Change No. 3
License No. DPR-31

UNITED STATES
ATOMIC ENERGY COMMISSION
WASHINGTON, D.C. 20545

Docket No. 50-250

Change No. 3
License No. DPR-31

Figure 3.2-3. Power Spike Factor versus Elevation

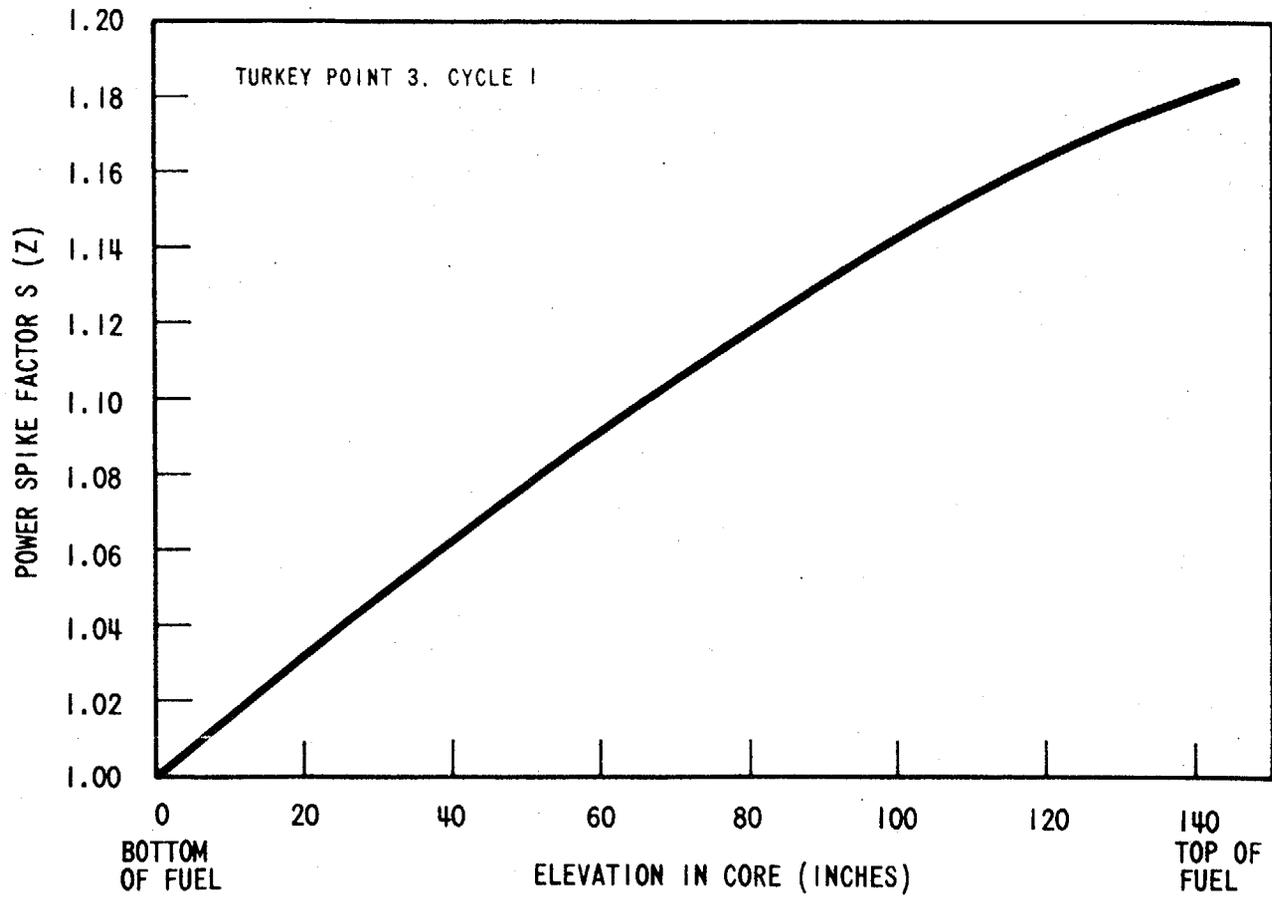
- g. If the L factor used in Section 6.c is 0.95 axial surveillance of F_Z^N shall consist of:
- 1) Two traverses with the movable in-core detectors in appropriate alternate pairs of channels shall be taken every eight hours, or at a frequency of 0, 30, 60, 120, 180, 240, 360 and 480 minutes following accumulated control rod motion of five steps except for control rod exercises limited to within 10 steps from the top of the core. From the traverses, determination that $F_Z^N \leq 1.63/S(Z)$ is the densification penalty factor as a function of core height shown in Fig. 3.2-3. This allows 4% measurement error.

The measured value of F_q^N must be additionally corrected by including a penalty as shown on Figure 3.2-3 (at the appropriate core location) to account for fuel densification effects before comparison with the limiting value above.
